RE: Word of Life Elementary School

We request reconsideration for a septic system at Lot 1, Block 1, Cherokee Sunrise West. Based on subsequent discussions we have had with the Sedgwick County Health Department, we offer the following plan:

RE: Final Plat of Cherokee Sunrise West
S/D 81-90

Re: S/D 81-90 - Final plat of Cherokee Sunrise West

SITE PLAN
1" = 80'-0"

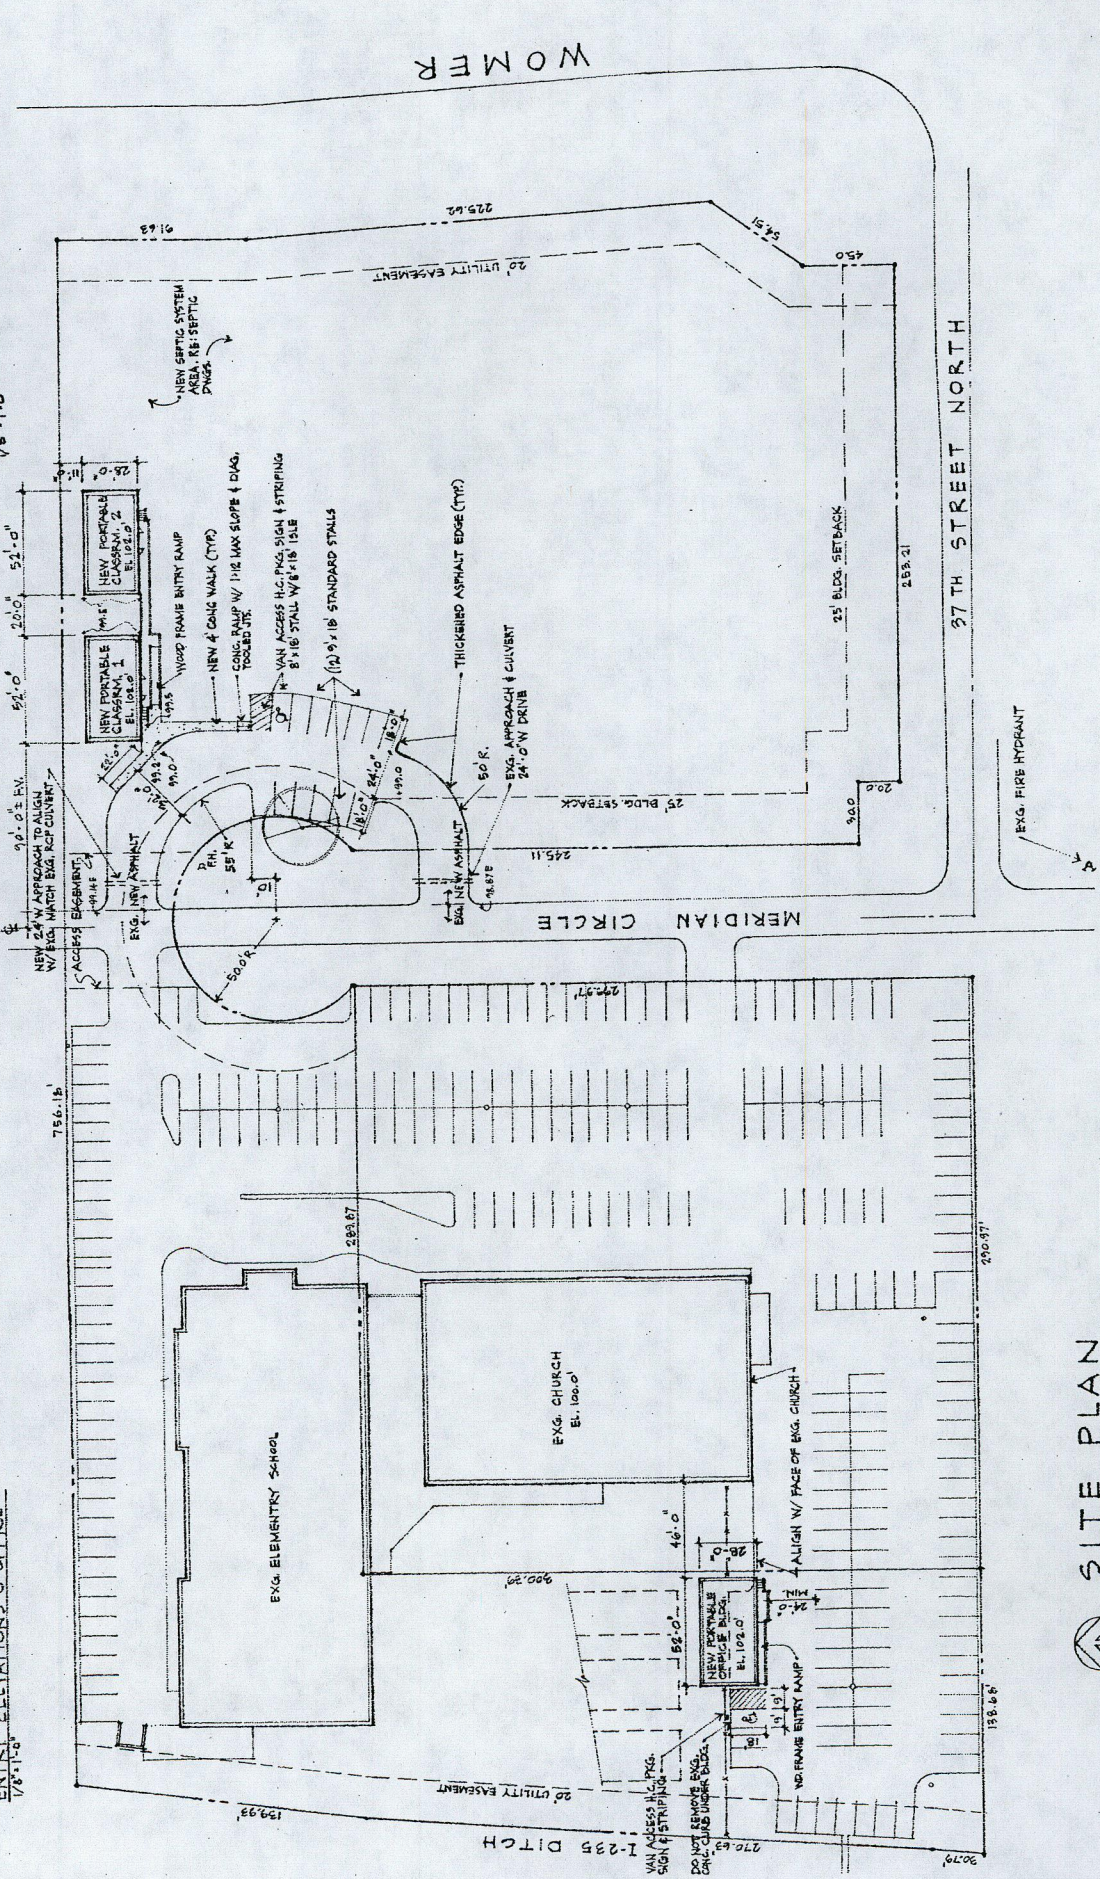
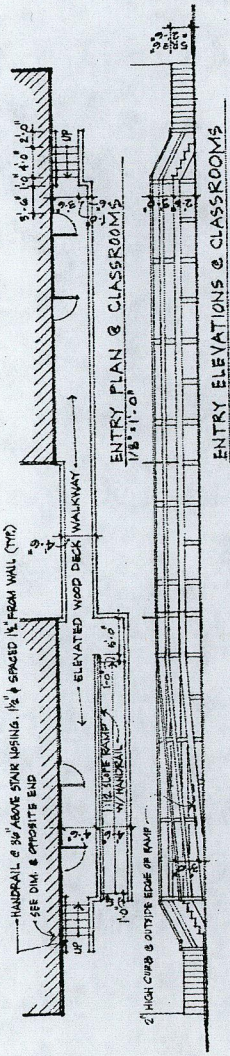
Word of Life is willing to sign a legally binding document guaranteeing that Word of Life will tie into a public waste system within a 3-year period. The existing system serving the Church will be repaired or upgraded to the satisfaction of the Health Department. No requests for additional private septic systems will be made for this property beyond the current request. Any permanent building projects which we propose for development on this site prior to or after the 3-year period will include public tie in at the time of development.
